SECTION 009111.13 - ADDENDUM NUMBER 3

- 1.1 **DATE: DECEMBER 17 2024**
- 1.2 **PROJECT: FULTON CO. PUBLIC LIBRARY: ADDITION, RENOVATIONS & SITE IMPROVEMENTS TO: AUBBEE, FULTON & ROCHESTER LIBRARIES**
- 1.3 **PROJECT NUMBER: 24029**
- 1.4 **OWNER: FULTON COUNTY PUBLIC LIBRARY, 320 W. 7TH STREET, ROCHESTER, IN 46975**
- 1.5 **ARCHITECT: ODLE MCGUIRE SHOOK MATTHEW R. MAYOL #IN19900090**

- A. AUBBEE BRANCH: C2.0, C3.1, C7.0 AND C7.1
 - B. FULTON BRANCH: C1.0, C7.0, C7.1 AND L100
 - C. ROCHESTER LIBRARY: C0.0, C1.0, C2.0, C3.0, C3.1, C7.0, DA102, A102, A103, A105, A401, A202, A203, A501.

A202
 INTERIOR ELEVATIONS

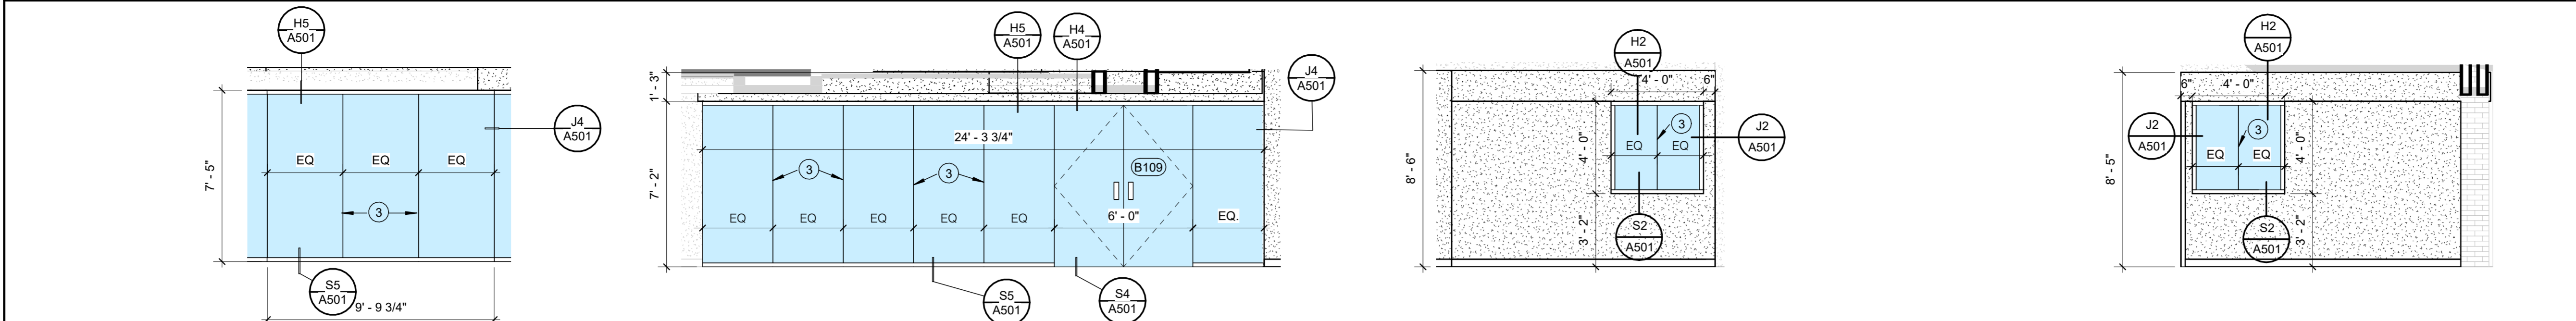
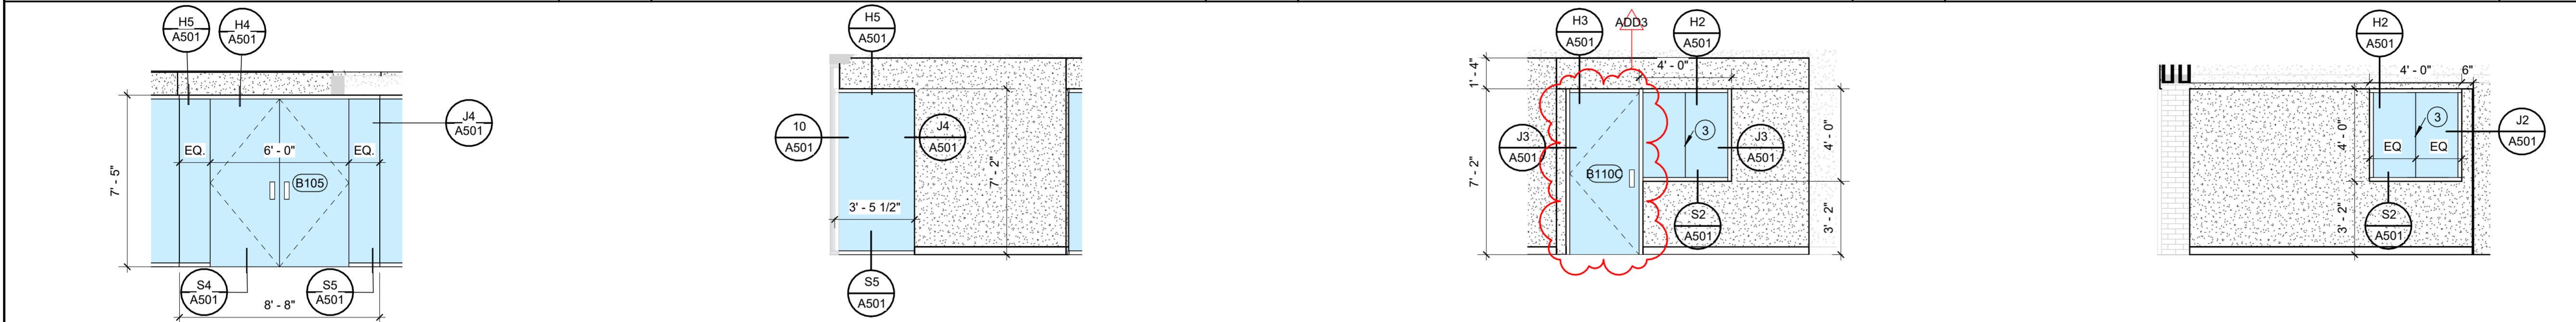
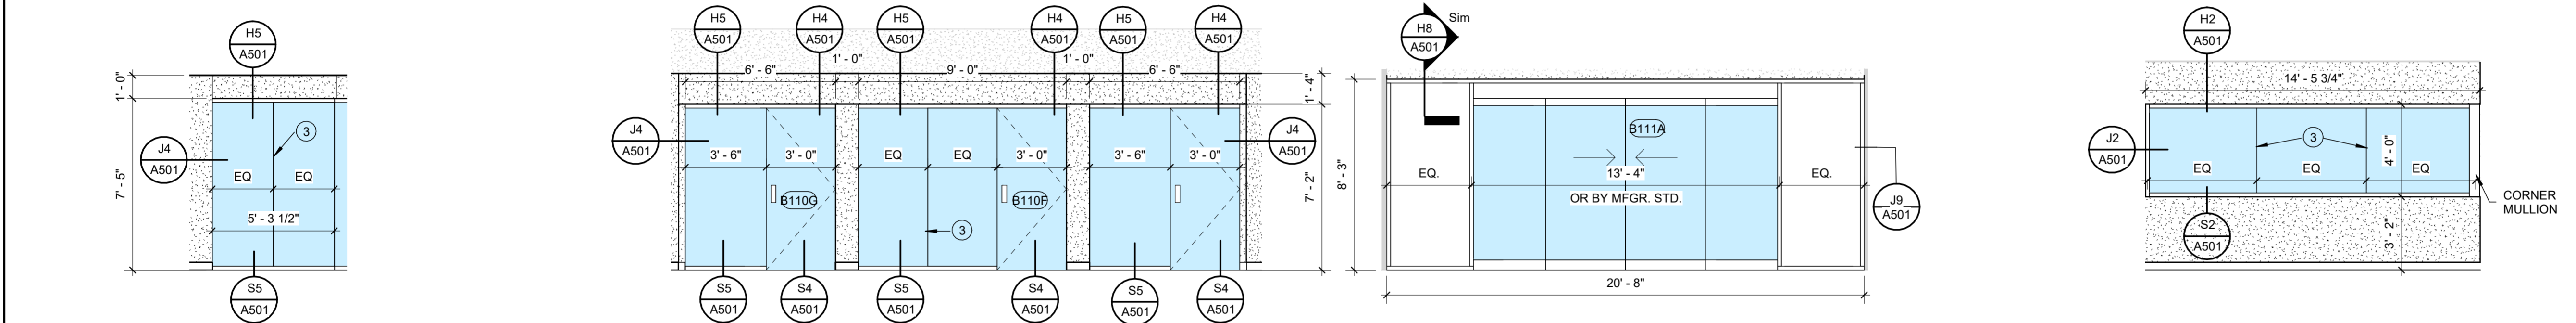
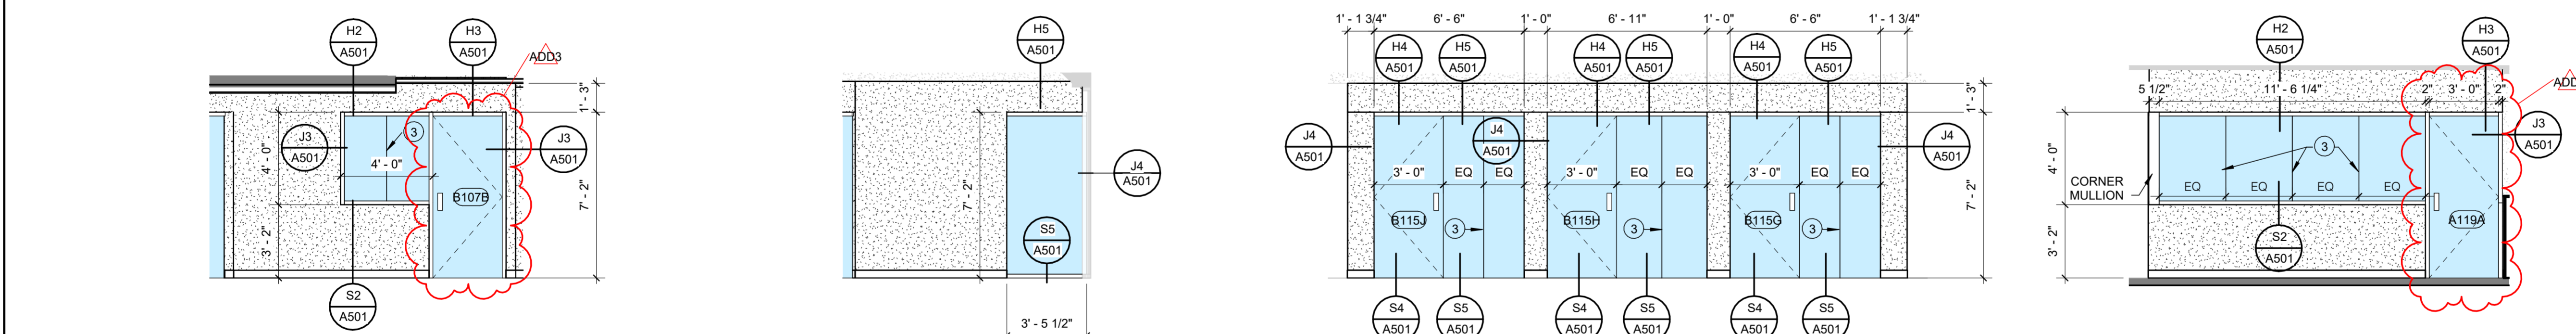
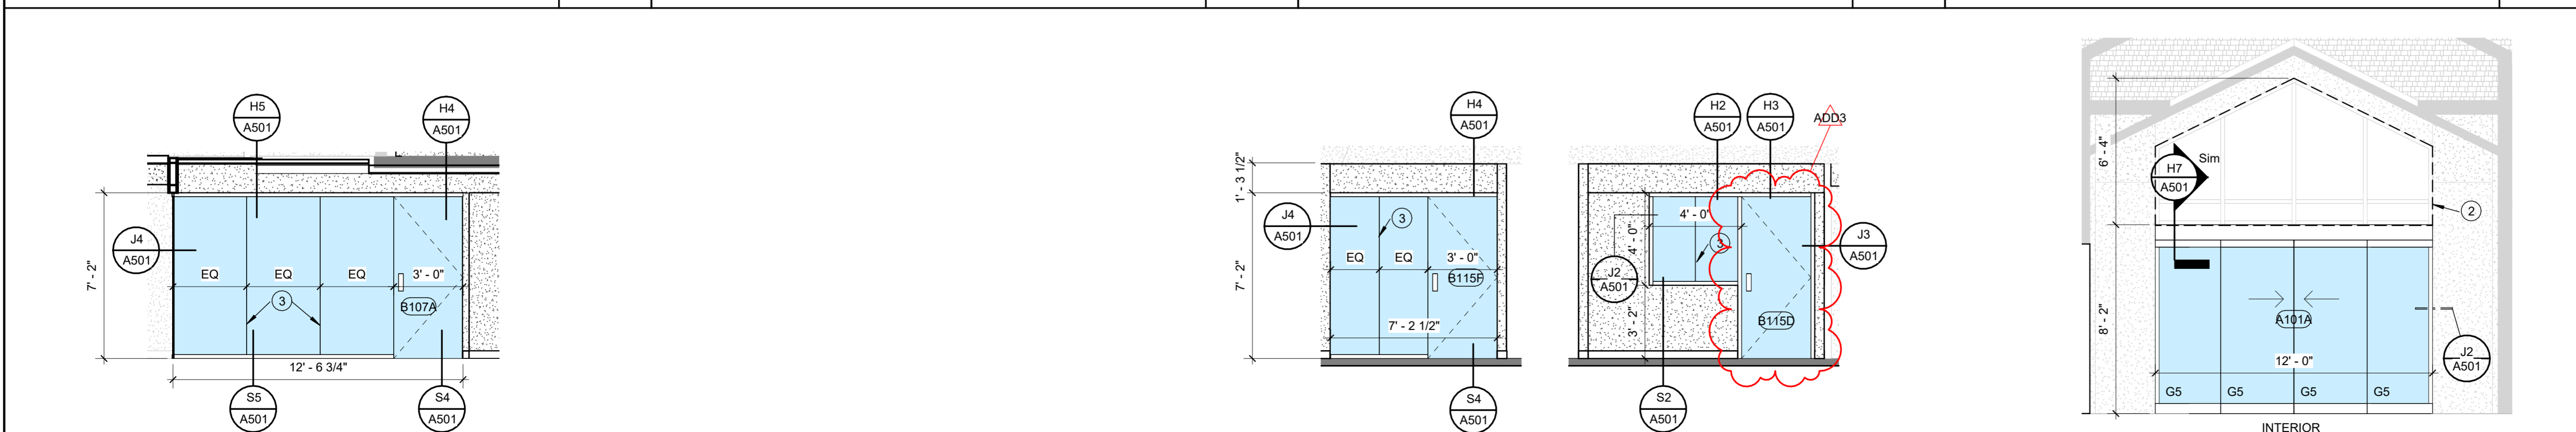
16. Q: Doors A119A, B101B, B107B, B108B, B110C, and B115D are listed as Type E all glass yet are drawn as a style and rail type door on the elevations. Which is the correct door type?

- a. A: A119A, B101B, B107B, B108B, B110C, B115D to be TYPE E; Reference revised INTERIOR ELEVATIONS Drawings A202, A203 in this Addendum.
17. Q: Door B110E seems to be missing from the door schedule.
